Technical Evaluation Report on the Content of the U.S. Department of Energy's Yucca Mountain Repository License Application

Postclosure Volume: Repository
Safety After Permanent Closure

Manuscript Completed: July 2011

**Office of Nuclear Material Safety and Safeguards
Division of High-Level Waste Repository Safety**

Figure 6-1. Potential Flow Pathways in the Engineered Barrier System (SAR Figure 2.3.7-8; DOE, 2008ab)

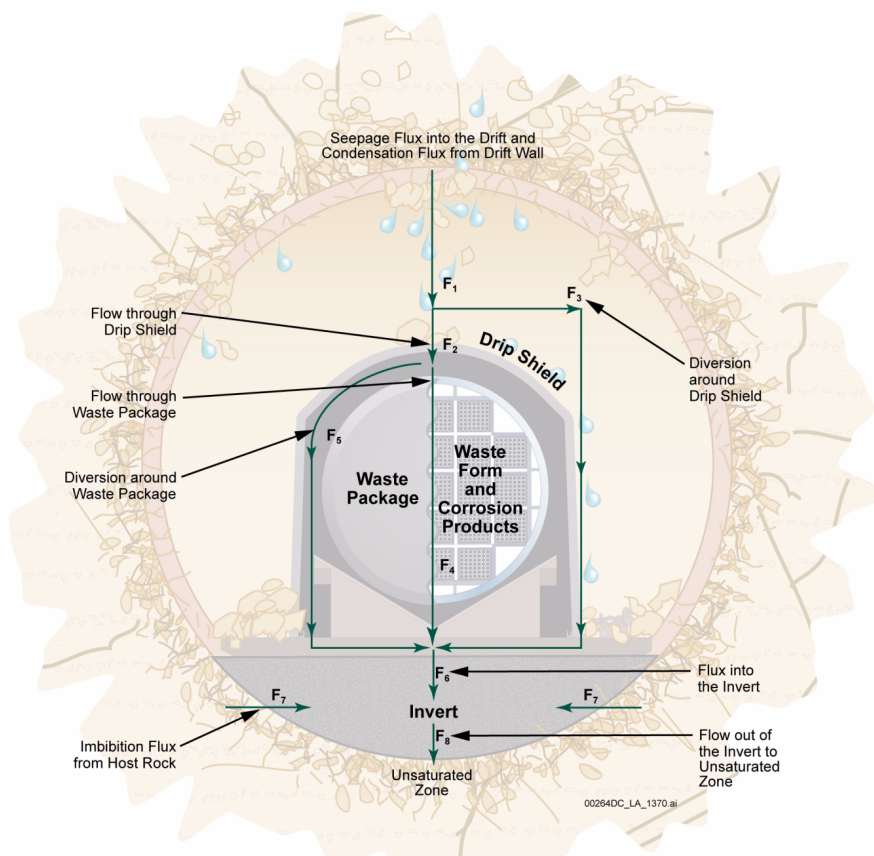
DOE described the flow pathways and flux rates (F1–F8) in the engineered barrier system flow abstraction as follows (Figure 6-1): the F1 flow path accounts for the total dripping flux from a drift wall. The total dripping flux is the sum of the seepage flux arriving at the drift wall from above and the condensed water on drift walls (TER Section 2.2.1.3.6.3.4); these are direct

inputs to the engineered barrier system flow abstraction. The F2 flow path accounts for the flux through partially failed patches of the drip shield formed by general corrosion.
